## Table of Contents

The Blaine Aquifer is one of the first four aquifers required to be studied prior to December 1, 2016. The Daniel B. Stephens & Associates Inc. (DBS&A) team was selected by the TWDB to complete the brackish groundwater study of the Blaine Aquifer. DBS&A team members include John Shomaker & Associates, Inc. (JSAI), Allan R. Standen, LLC (ARS), and Michelle A. Sutherland, LLC. The project study area is shown in Figure 2-1.

Figure 5-2. Study area surface geology from Geologic Atlas of Texas (Barnes, 1974, Amarillo, Plainview, Lubbock, Big Spring, Wichita Falls-Lawton and Abilene sheets) and structure from Ewing (1991).

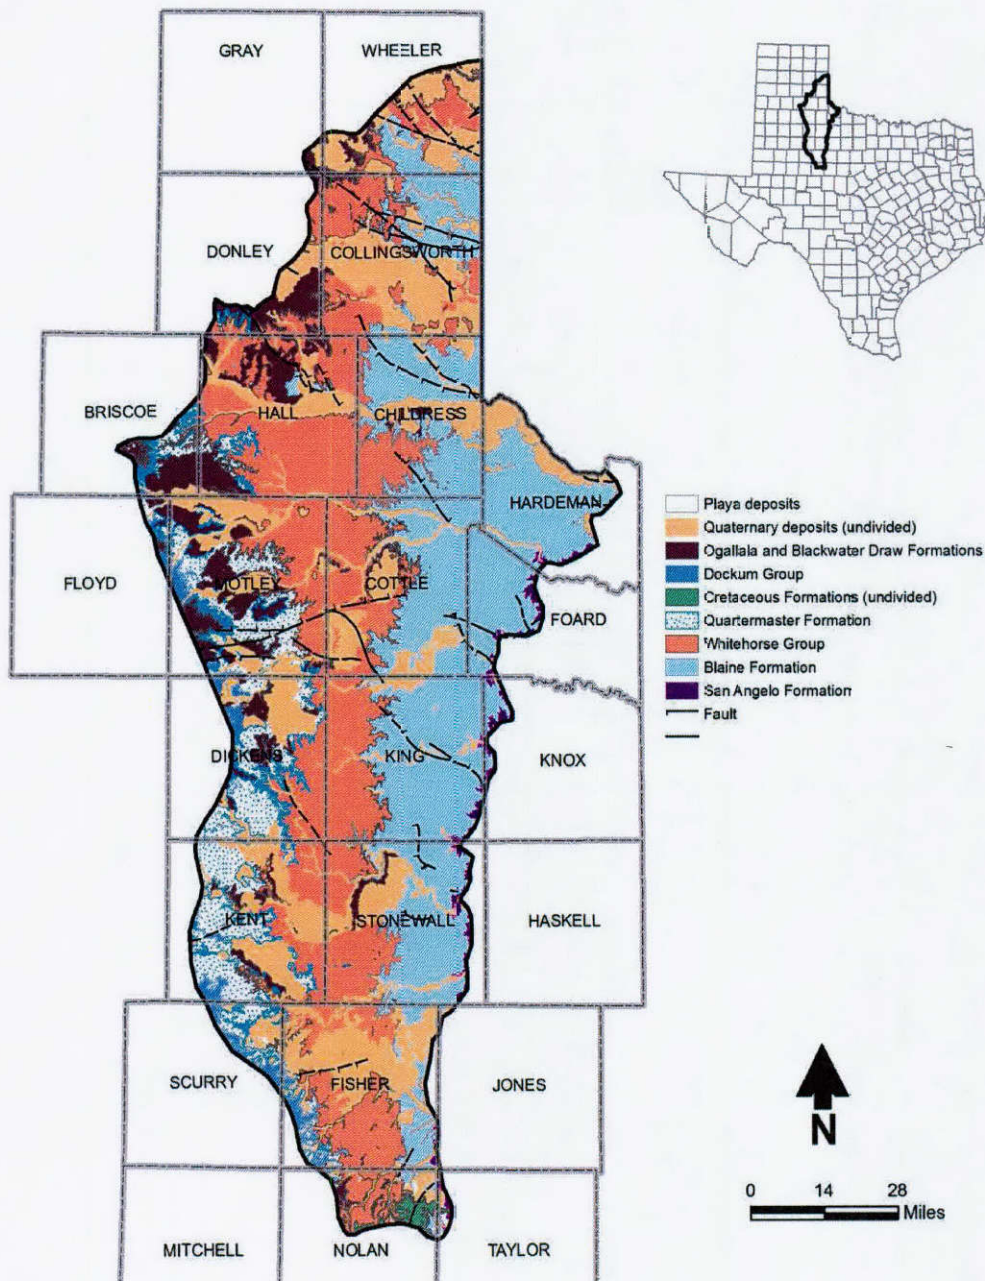
1. Figure 5-2. Please add the source of this data in the figure caption. Please consider listing geologic formations in the legend in stratigraphic (age) order, from youngest at the top to oldest at the bottom.

Figure 5-4. Bottom elevation of the Blaine Formation.

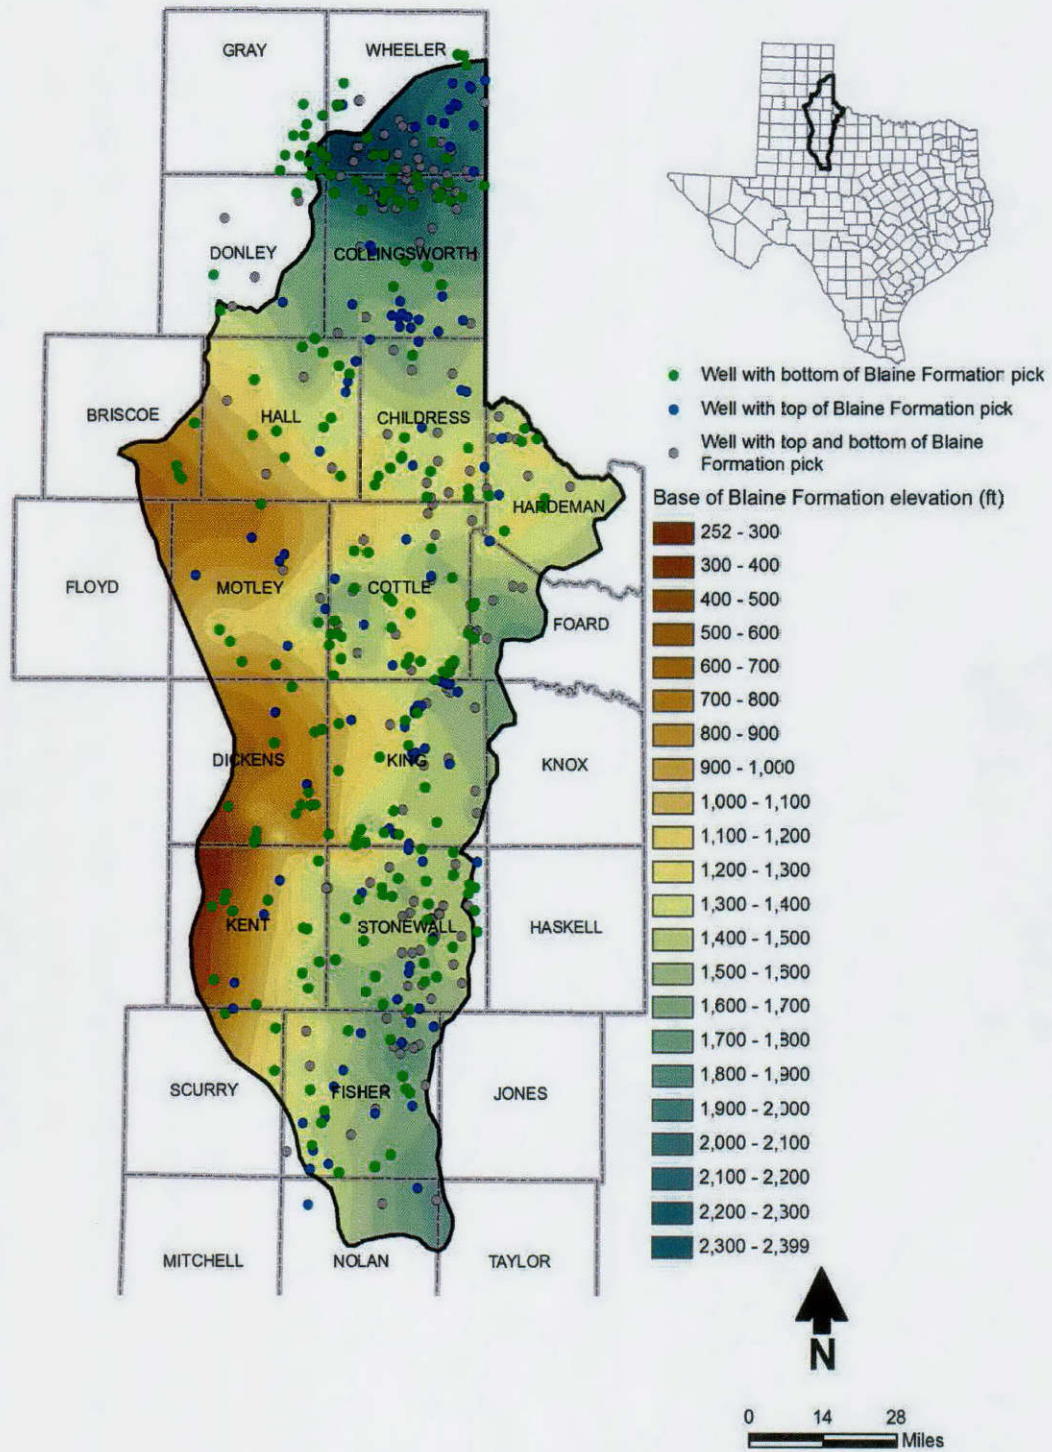
- d. Please modify the caption to more clearly state that the contours are in feet above the base of the Blaine Aquifer System.
8. Figures 5-4, 8-3, and 13-2. Please consider including additional figure for each map using a scale in depth below ground surface.

Figure 6-1. Blaine Aquifer system TDS from water wells.

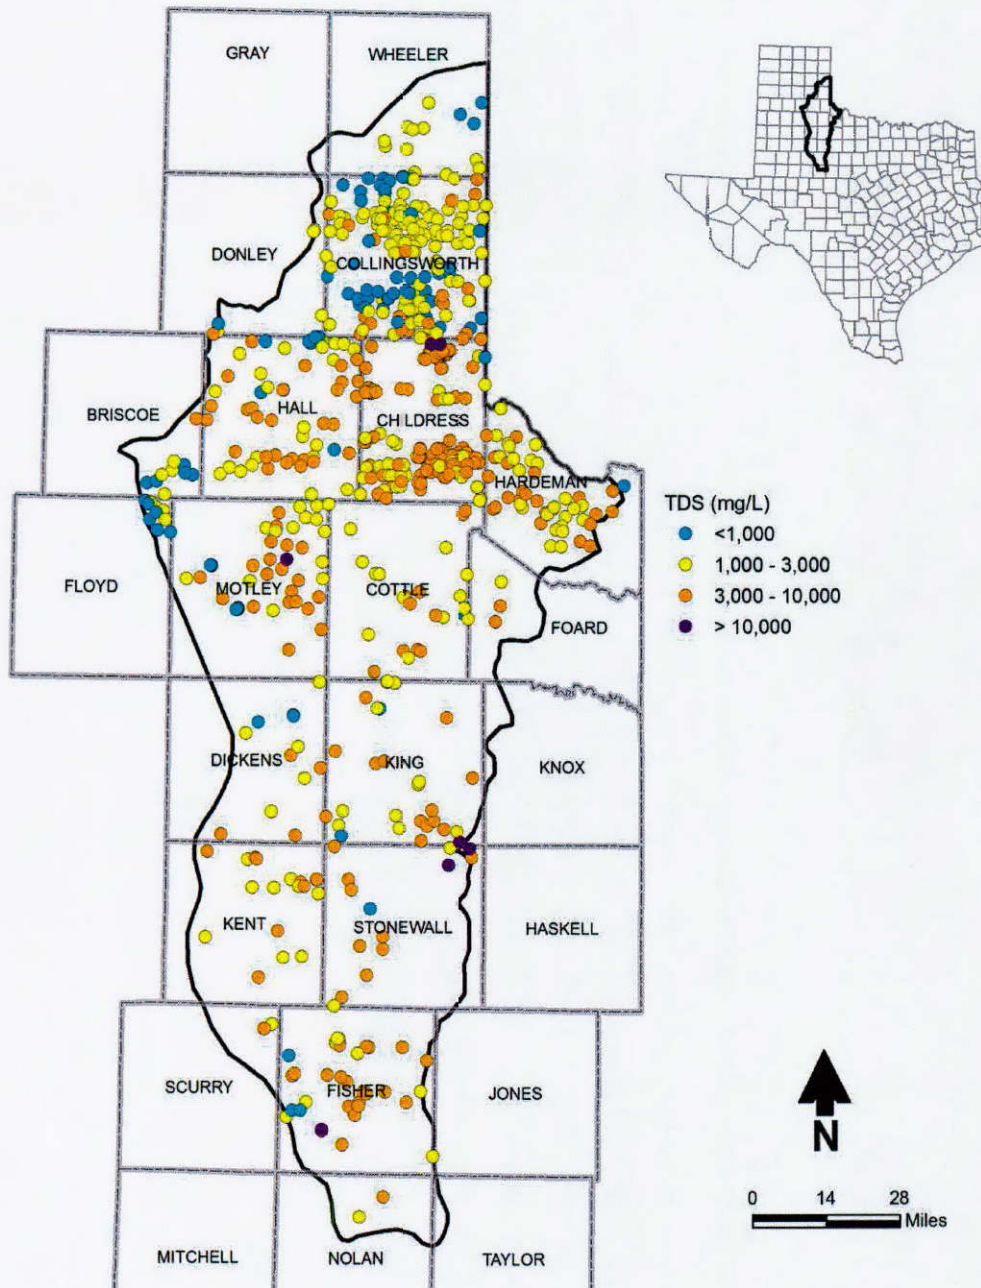
14. Figure 6-1. Please use colors for each salinity zone in this table. Refer to Contract Exhibit G BRACS Program Contract Data Requirements Section 5 (c). In addition, the well symbols can be improved by omitting the black circle borders.

Figure 6-3. Map of Blaine Aquifer salinity distribution and brine emission areas and location of Table 6-3 data points.

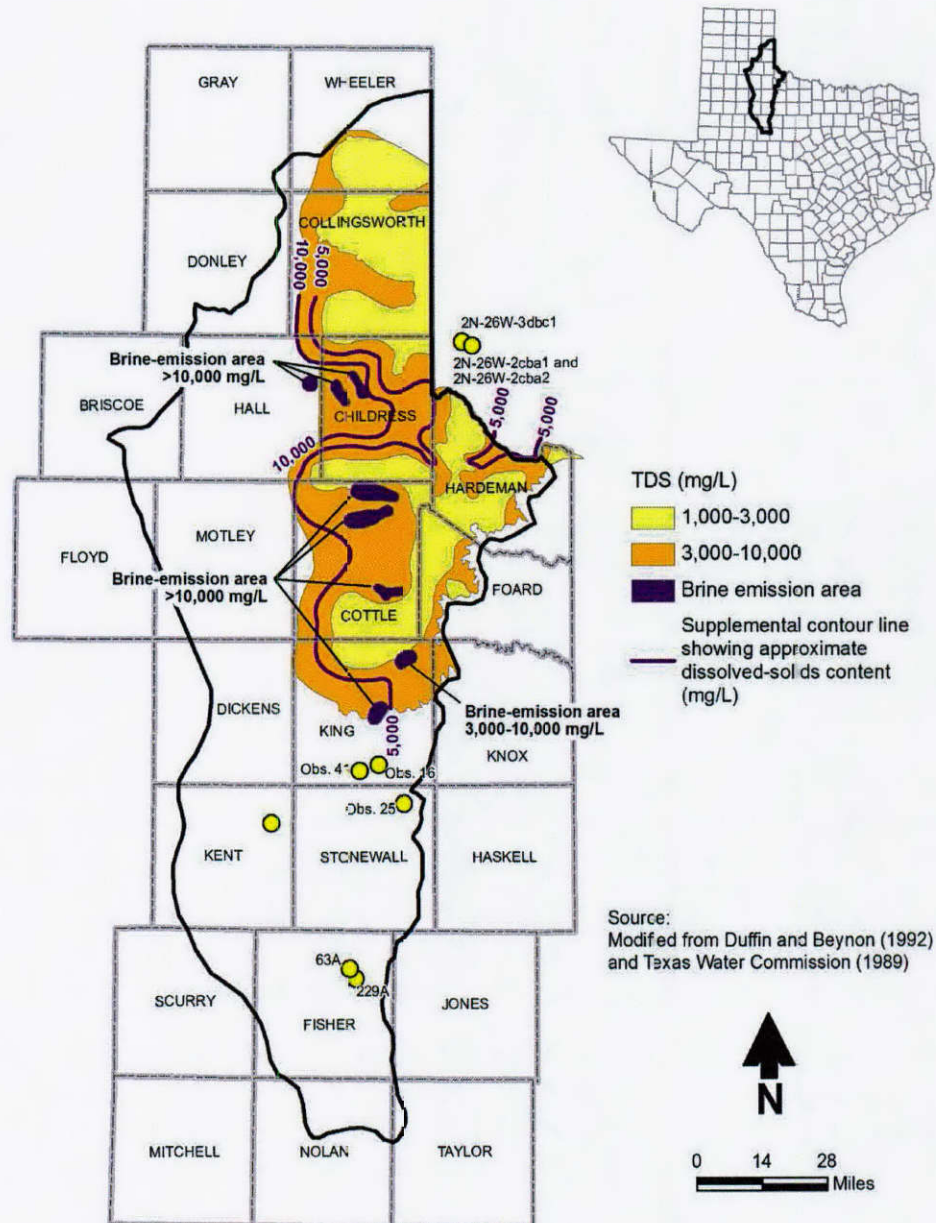
9. Figure 6-3. Please consider making the figure more legible.
10. Figures 7-2, 7-3, and 7-4. Please consider making the figures more legible.
11. Figure 8-2. Please consider including a line connecting the data points for the individual hydrographs

Figure 7-1. Regions covered by selected historical reports. R=Report, MR = Memorandum report, OFR = Open-File report, B= Bulletin, TWDB = Texas Water Development Board, TWBE = Texas Water Board of Engineers, USGS = U.S. Geological Survey.

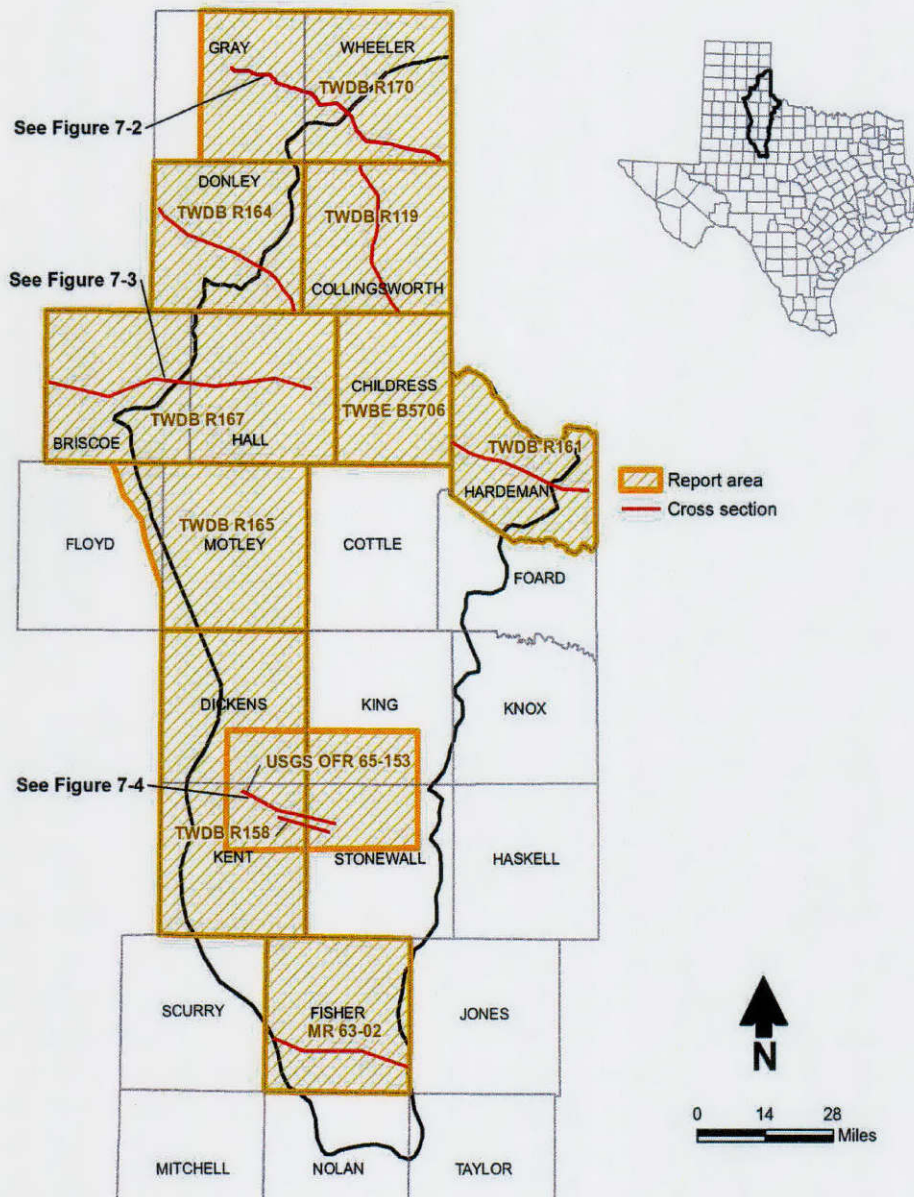
3. Figure 7-1. Please include definitions of acronyms used in the reference to reports in the figure caption.
4. Figure 8-3. Please add the modifier "static" to the caption "water level map" and state that this data is for the Blaine Aquifer system.

Figure 8-1. BEG and TDLR wells used for stratigraphic analysis.

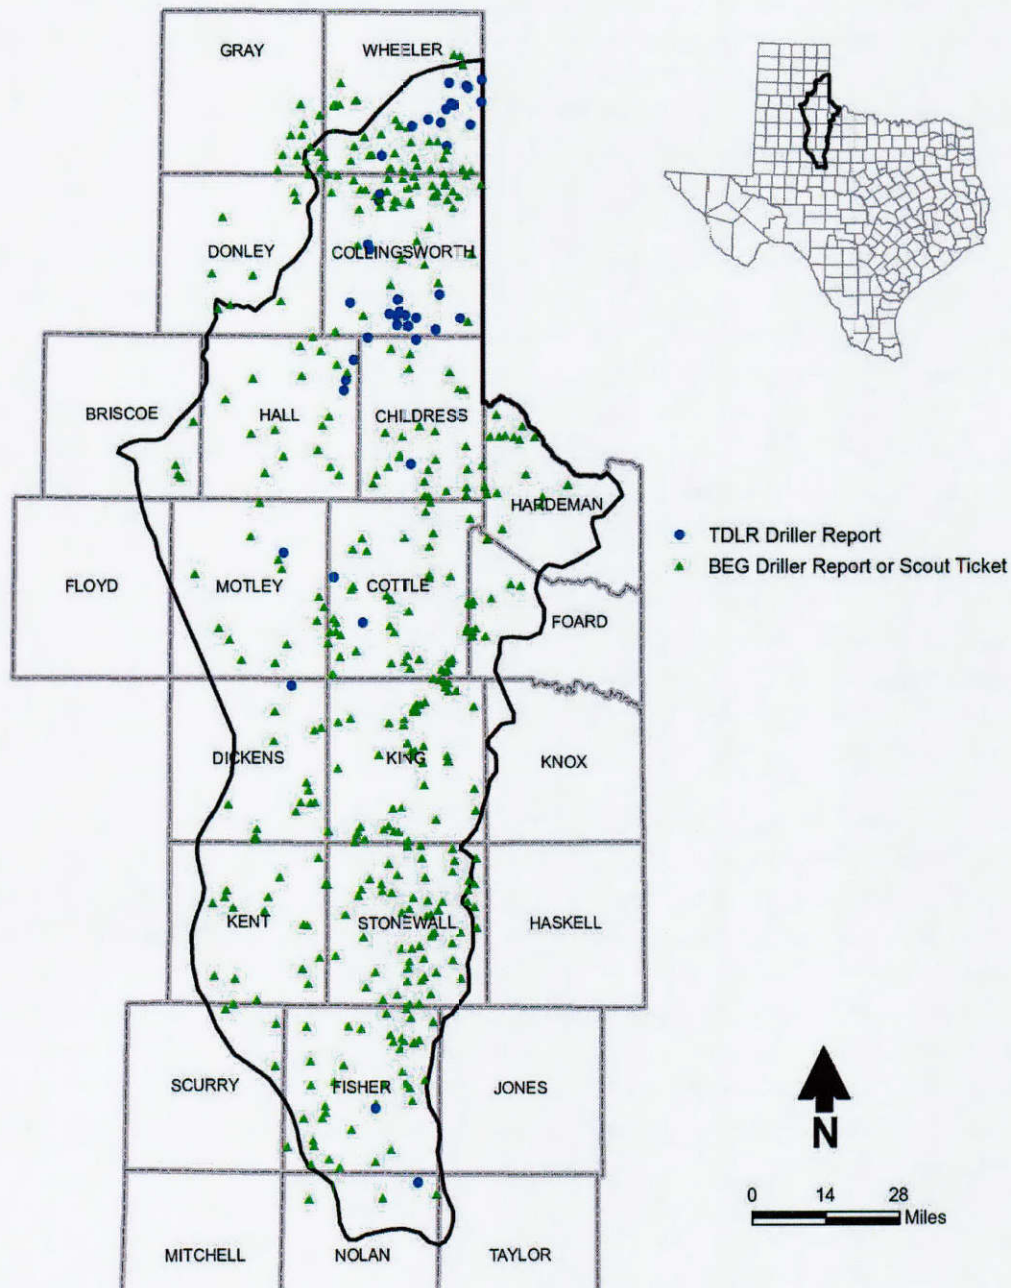
16. Please submit GIS polygon shape files for the potential production areas.
17. Please submit GIS point file used to create Figure 8-1 (BEG and TDLR wells used for stratigraphic analysis).

Figure 8-3. Blaine Aquifer system potentiometric surface based on static water level elevations, spring elevations, and published potentiometric surface maps from multiple time periods.

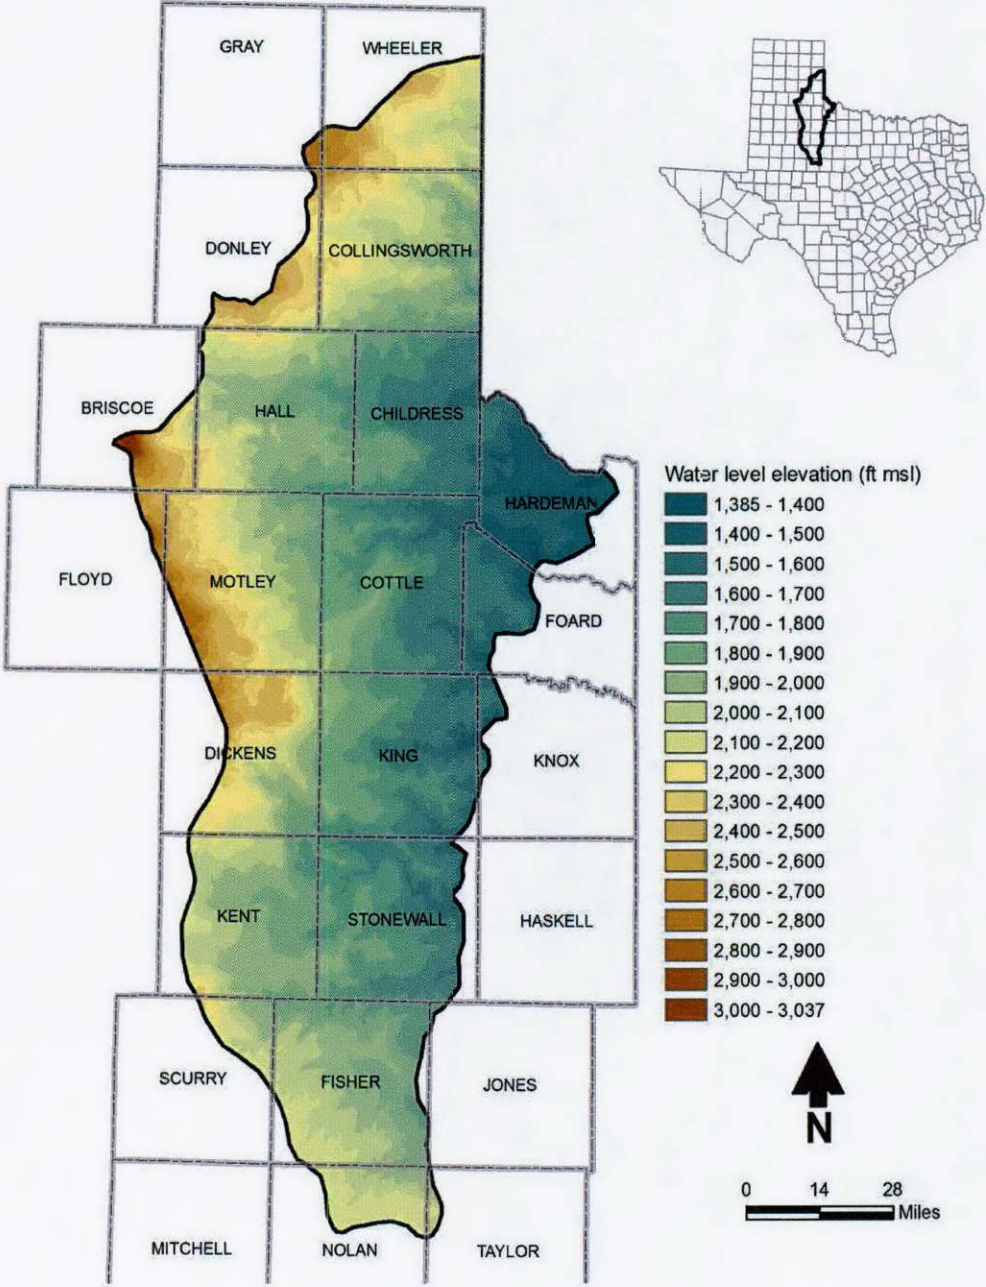
26. Figure 8-3 was prepared using static water level point data. Please provide a GIS point shapefile of this dataset that includes the well number (state\_well\_number; track\_number), static water level, and date of measurement.

Figure 10-4. Spring water quality and streams potentially receiving saline water from the Blaine Aquifer system.

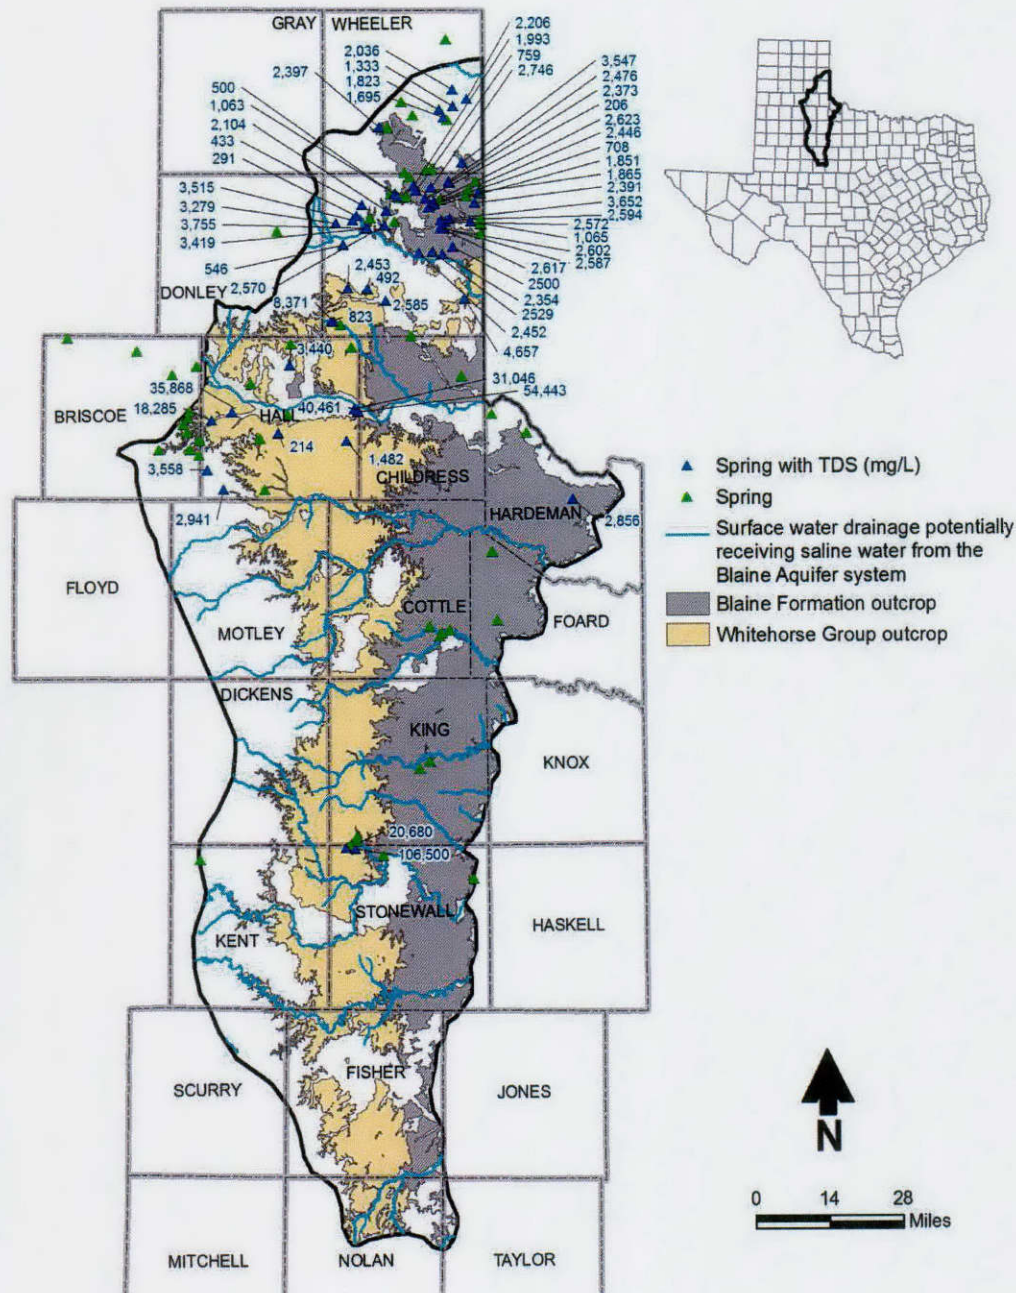
24. Section 8.3. Please provide a GIS file of the springs as shown on Figure 10-4.
25. Section 8.2. Please make sure the static water level data was obtained from TDLR SDR wells for the table new\_tblBracs\_SWL. Please indicate in Section 8.2, if these data points were used to prepare Figure 8-3. If not, please provide a discussion of why this data was not used.
